February 22, 2021

**Re: Comments of Horizon West Transmission, LLC on the Draft Environmental Impact Report for the Estrella Substation and Paso Robles Area Reinforcement Project, December 2020 (California State Clearinghouse No. 2018072071)**

Priska Dr

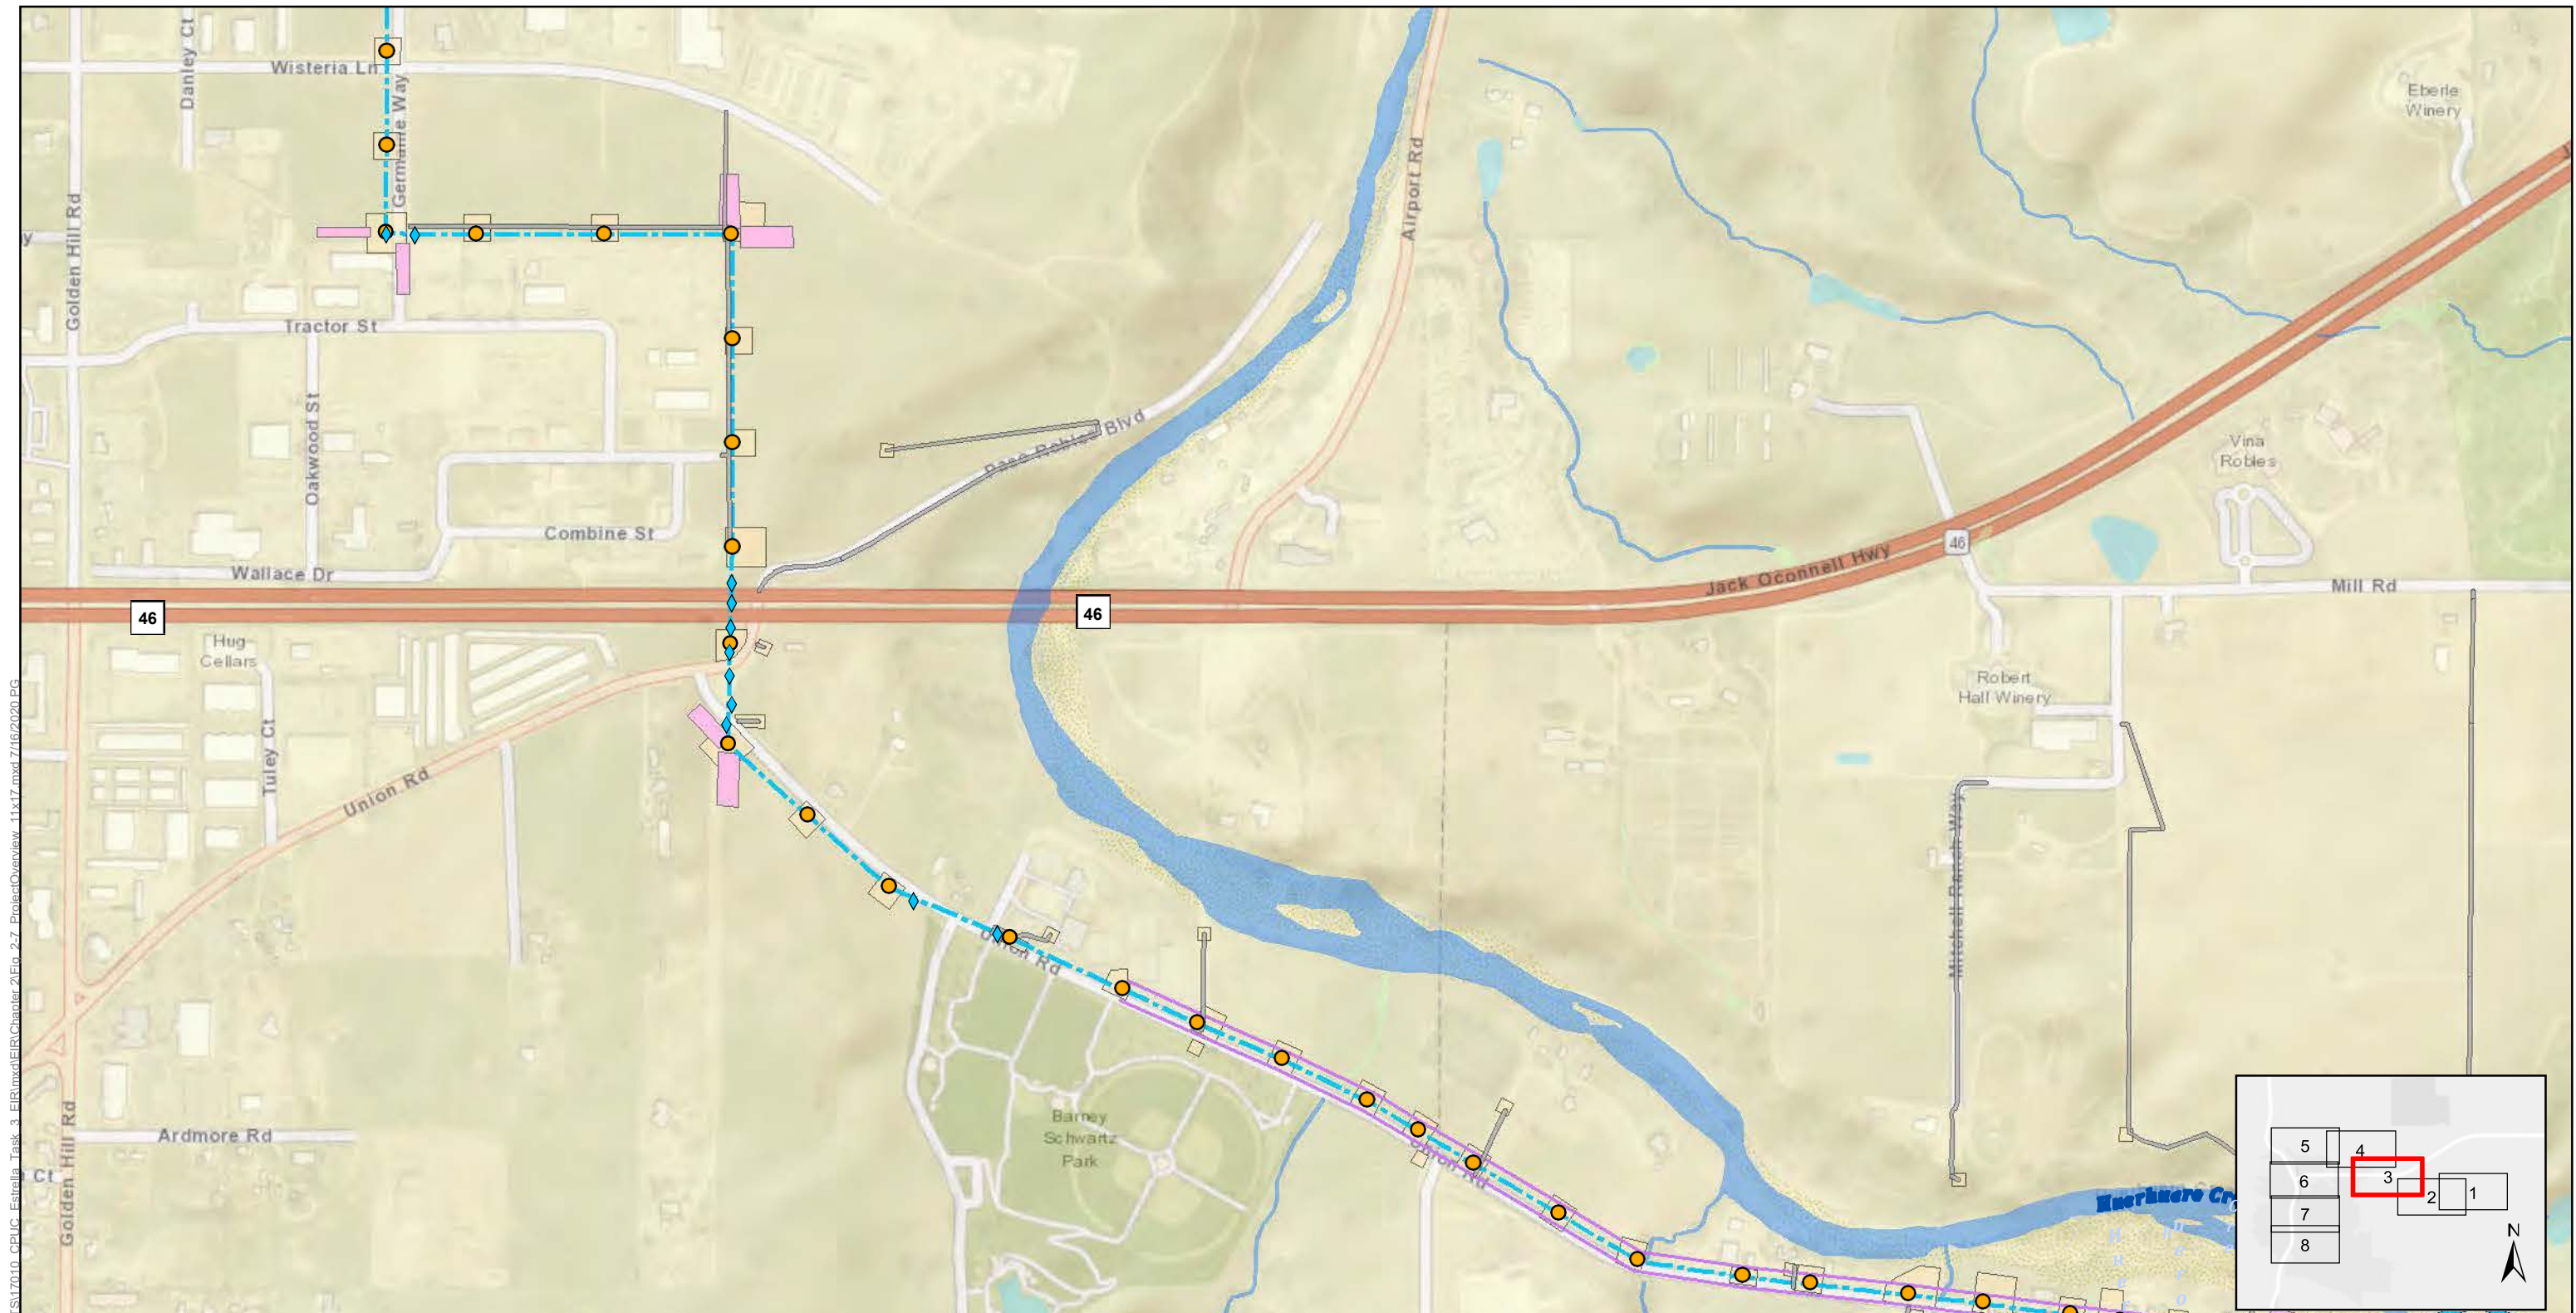
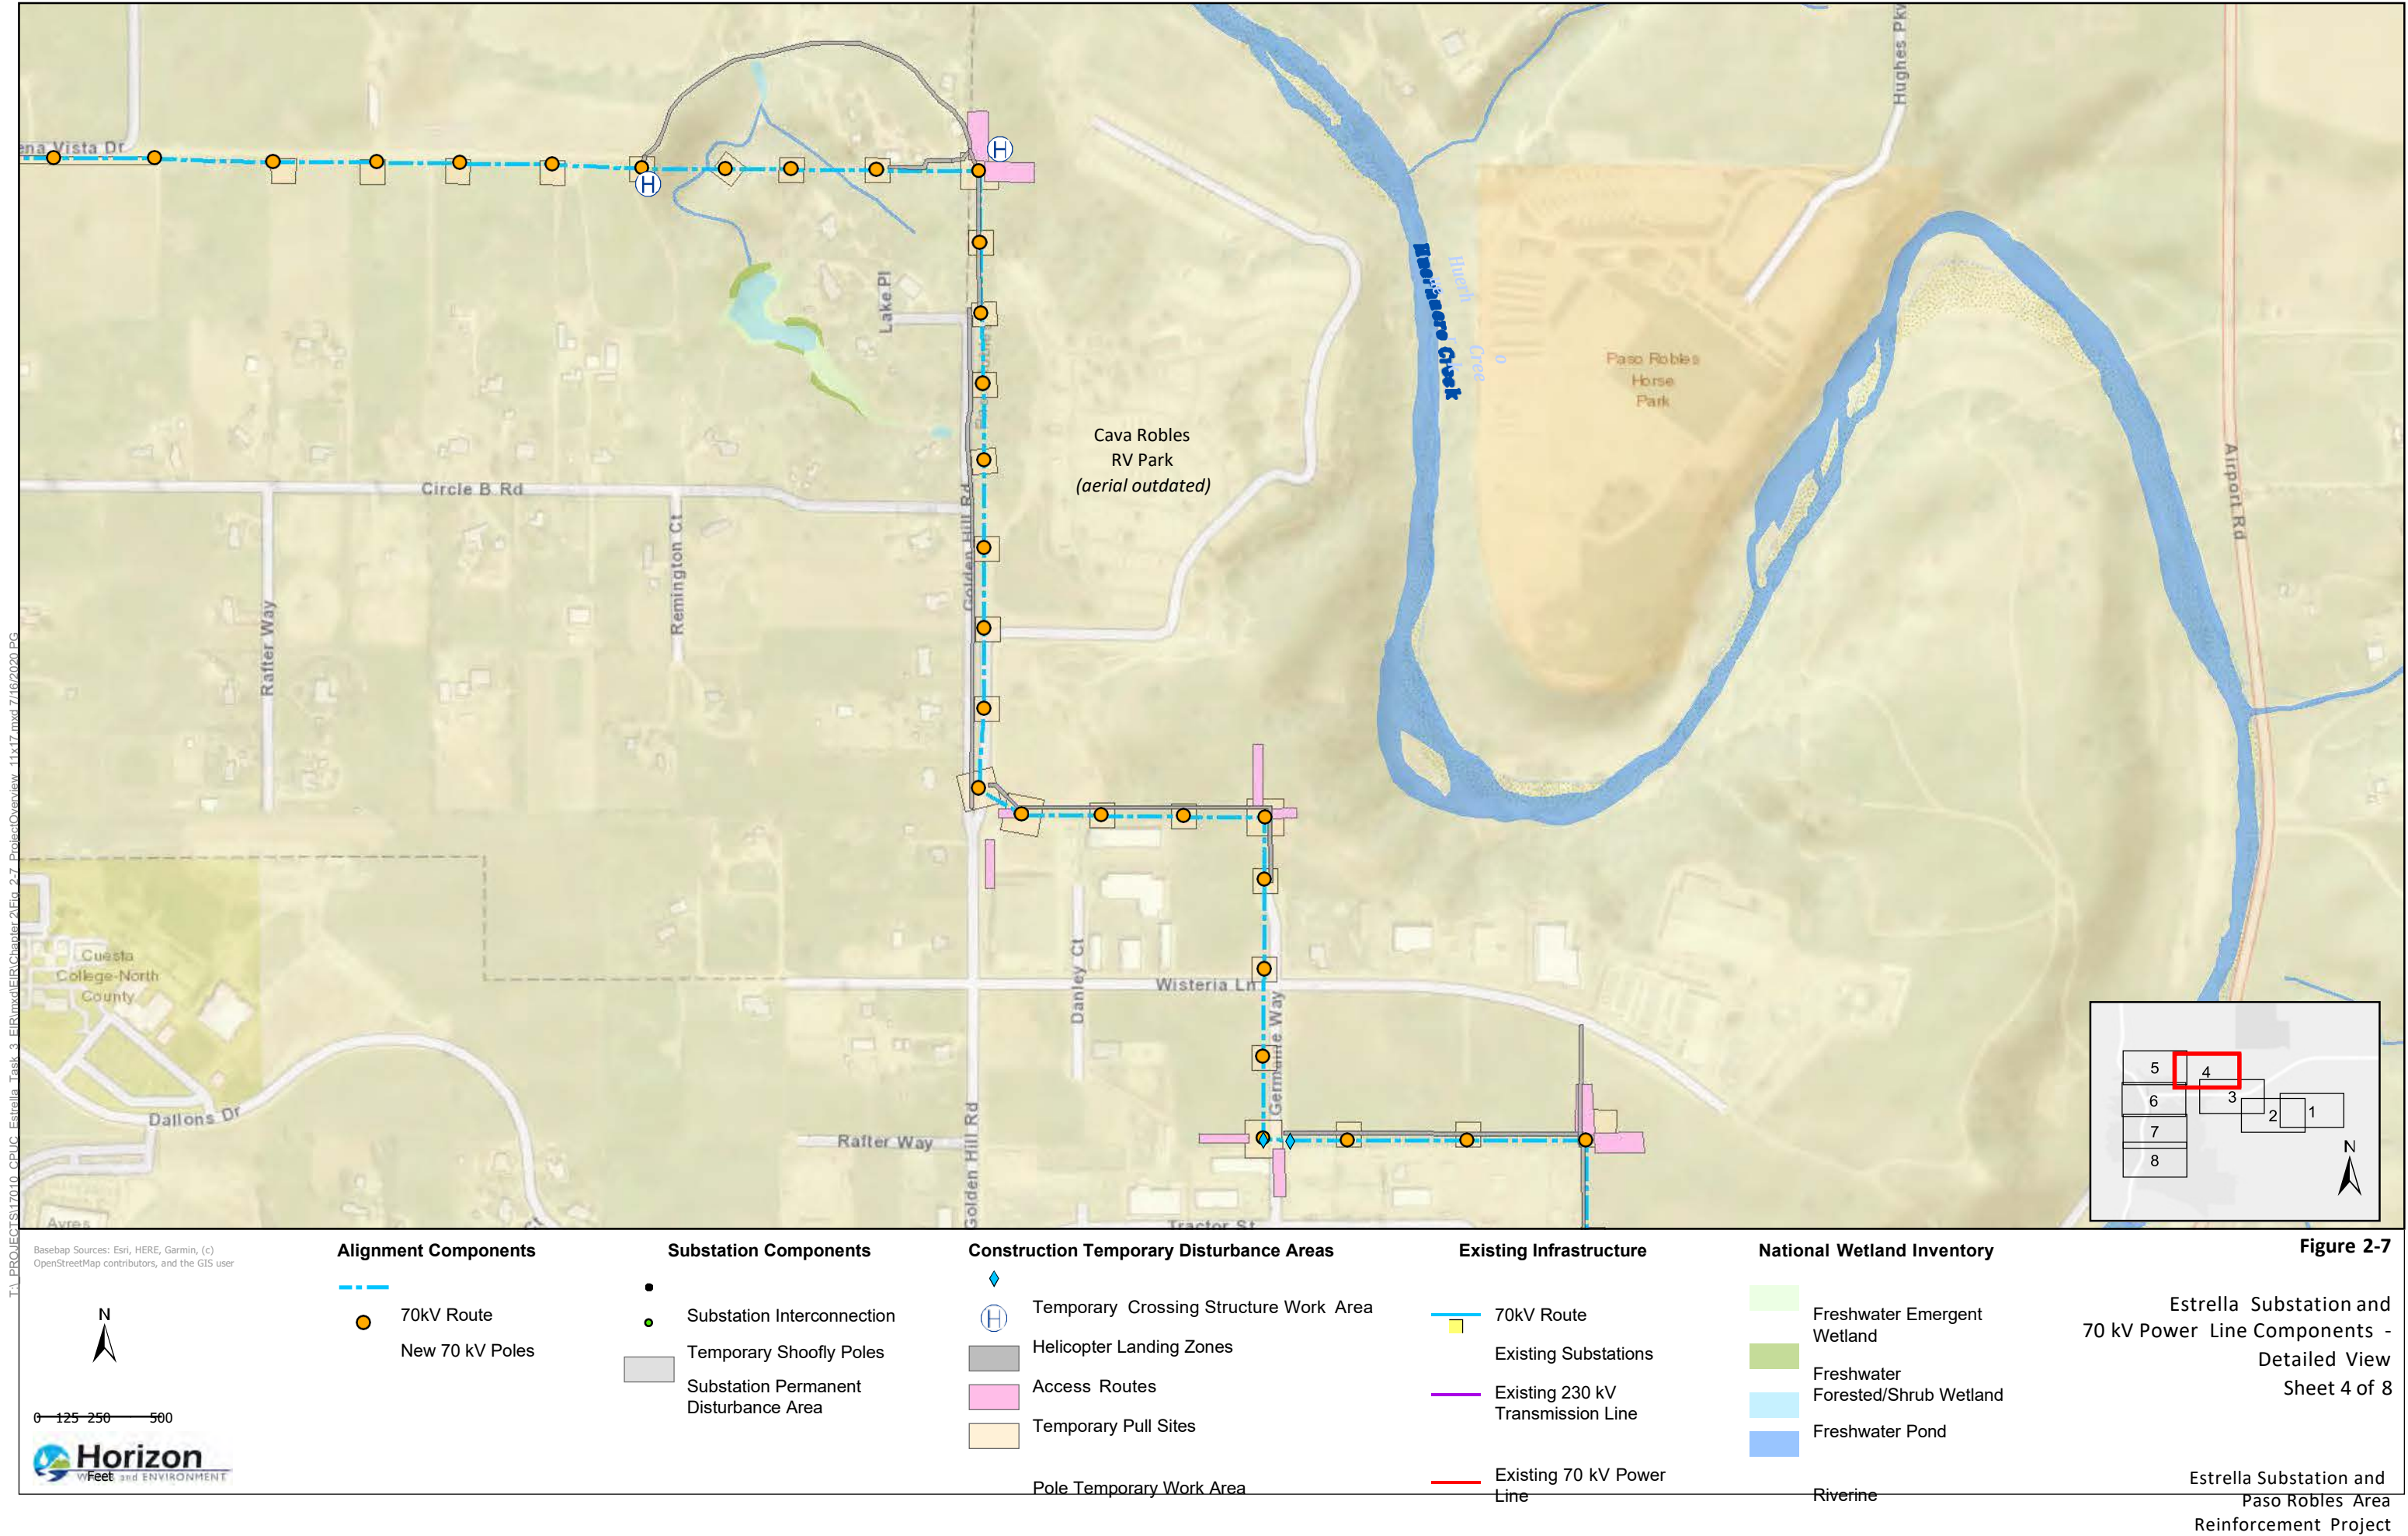
2-22	Figure 2-7	Replace figure to include new substation parcel and update temporary and permanent disturbance areas
2-46	Figure 2-11	Replace figure with new substation layout
2-47	Figure 2-12	Replace figure with new substation layout
2-48	Figure 2-13	Replace figure with new substation layout
2-49	The fenced portion of the 230 kV substation would be approximately 4 acres in size. An approximately 7-foot-tall chain-link fence with an additional 1 foot of barbed wire would be installed around the remaining perimeter of the 230 kV substation.	<p>Please revise text to read:</p> <p>The fenced portion of the 230 kV substation would be approximately 4 acres in size. <del>An approximately 7-foot-tall</del> chain-link fence, <u>a minimum of 7 feet tall</u>, with an additional 1 foot of barbed wire would be installed around the remaining perimeter of the 230 kV substation.</p>
2-56	The equipment and facilities associated with ultimate substation buildout would primarily be placed within the fence line of the already-constructed Estrella Substation. The anticipated layout of the Estrella Substation at ultimate buildout is shown in Figure 2-18. The additional 230/70 kV transformer under ultimate buildout is assumed to include the same amount of mineral oil (16,000 to 18,000 gallons) as described for the Proposed Project (see Section 2.3.1), and the same secondary containment structure (i.e., designed to allow sufficient freeboard to include the oil volume of the transformer plus the precipitation from a 25-year, 24-hour storm event). The additional 230 kV interconnection is assumed to include similar structures (LSTs) and follow a similar interconnection process to that described for the Proposed Project in Section 2.3.1 under the header for “230 kV Transmission Interconnection.” The additional 70/21 kV transformers that may be installed to support additional distribution feeders are assumed to include secondary containment, as necessary to contain spills of any stored mineral oil.	<p>Please revise text to read:</p> <p>The equipment and facilities associated with ultimate substation buildout would primarily be placed within the fence line of the already-constructed Estrella Substation. The anticipated layout of the Estrella Substation at ultimate buildout is shown in Figure 2-18. The additional 230/70 kV transformer under ultimate buildout is assumed to include the same amount of mineral oil (16,000 to 18,000 gallons) as described for the Proposed Project (see Section 2.3.1), and the same secondary containment structure (i.e., designed to allow sufficient freeboard to include the oil volume of the transformer plus the precipitation from a 25-year, 24-hour storm event). The additional 230 kV interconnection is assumed to include similar structures (LSTs) and follow a similar interconnection process to that described for the Proposed Project in Section 2.3.1 under the header for “230 kV Transmission Interconnection.” The additional 70/21 kV transformers that may be installed to support additional distribution feeders are assumed to include secondary containment, as necessary to contain spills of any stored mineral oil.</p>
